HADLEY SUBDIVISION

APPLICATION NUMBER 13 DATE January 4, 2007
APPLICANT Hadley Subdivision
REQUEST Subdivision

HADLEY SUBDIVISION

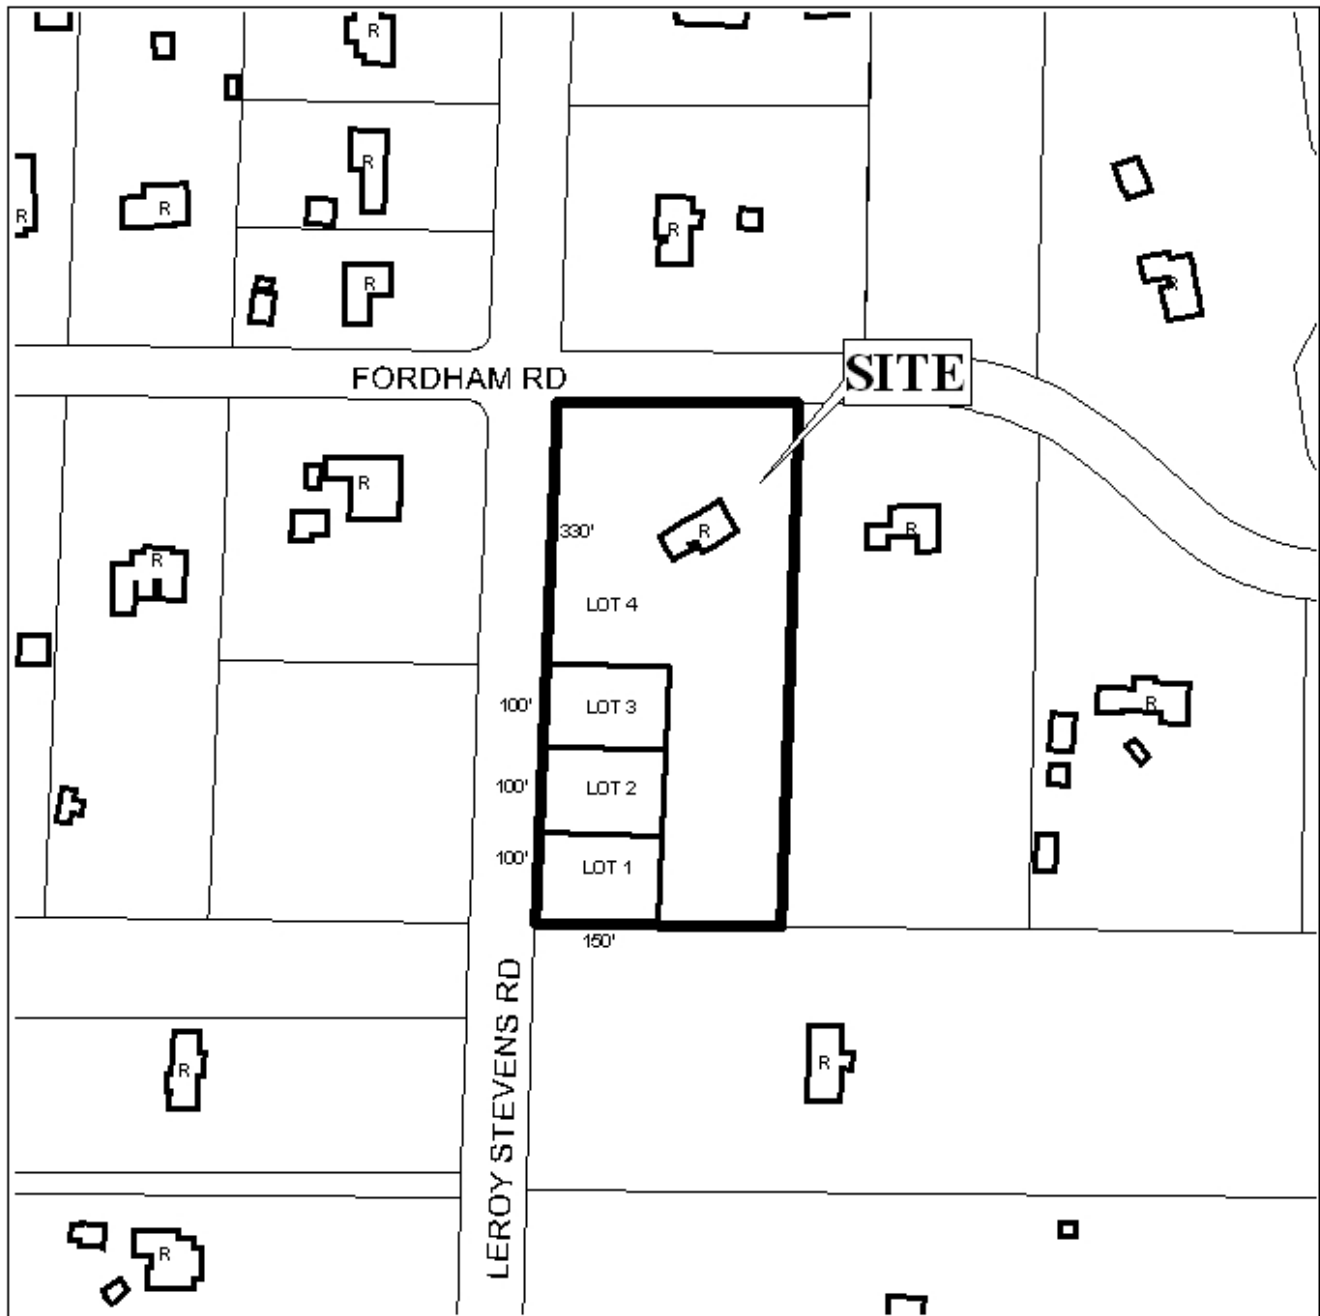
The site fronts Leroy Stevens Road and Fordham Road, and have an 80-foot and 60-foot rights-of-way, which are in compliance with the minor street standards of the Subdivision Regulations. As a means of access management, Lots 1, 2 & 3 should be allowed one curb cut each to Fordham Road and Lot 4 should be allowed one curb cut to Fordham Road and Leroy Stevens Road, all curb cuts location, size and design should be approved by County Engineering.

The 25-foot minimum building setback lines, required in Section V.D.9., are not shown, but would be required on the final plat along Leroy Stevens Road and Fordham Road, if approved.

With a waiver of Section V.D.3., the plat will meet the minimum requirements of the Subdivision Regulations and is recommended for Tentative Approval subject to the following conditions: 1) the placement of a note on the final Plat stating that Lots 1-3 be allowed one curb cut each to Fordham Road and Lot 4 be allowed one curb cut to Fordham Road and Leroy Stevens Road, all curb cuts location, size and design are to be approved by County Engineering; 2) provision of a certification letter from a licensed engineer to the Planning Section of Urban Development, certifying that the stormwater detention, drainage facilities, and release rate comply with the City of Mobile stormwater and flood control ordinances, prior to the signing and recording of the final plat; 3) the placement of a note on the final plat stating that any property that is developed commercially and adjoins residentially developed property shall provide a buffer, in compliance with Section V.A.7. of the Subdivision Regulations; and 4) the placement of the 25-foot minimum building setback lines on the Final Plat.
